WDG File: 008-20

Project: 1842 King Street East  
File No: **ZAC-21-021**  
Comment Response#: 2

Document(s): Tree Protection Plan (2021-09-29)  
Landscape Plan (2021-09-29)  
Urban Design Brief (October 2021)

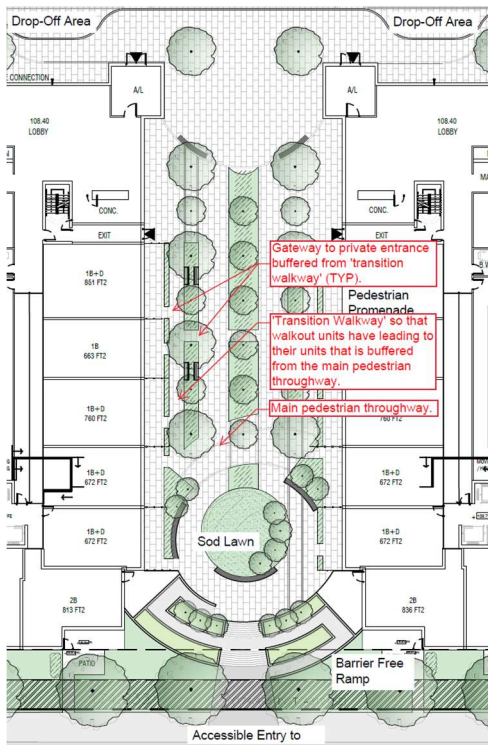
**Comment: Landscape Plan**

As per staff's previous recommendation, please consider enhancing the buffers between grade-related units facing the internal mews and public walkways to improve privacy and amenity for those residents at grade.

**Response:**

There is a hierarchy of space within the pedestrian promenade, as summarized below and annotated in the inserted sketch.

- Private space belonging to the associated ground floor walkout.
- Transition space, which is designed as a component of buffering between public and private space to permit those entering their private space to be able to do without walking directly into or out of the main pedestrian promenade. This also provides a neighbourhood feel for those living in the ground floor units, whereby they can move along the front of their unit and their neighbours with a degree of privacy that would not be available if they were accessed directly from the main promenade.
- Main promenade, which is designed to be wider than the transition walkway and, therefore, more intuitive for pedestrians as the primary north-south throughway.
